UNITED STATES PATENT AND TRADEMARK OFFICE

10/783,412

Office Action Summary

DETAILED ACTION

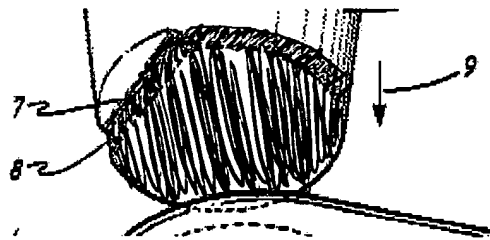
Re claims 1 and 8, Islip shows a carrier 1, a plurality of inserts 6, second connecting means 5,2 on the carrier, first connecting means (the bottom of the insert including 7,8 and the adjacent portion of the bottom of the insert shown shaded below).
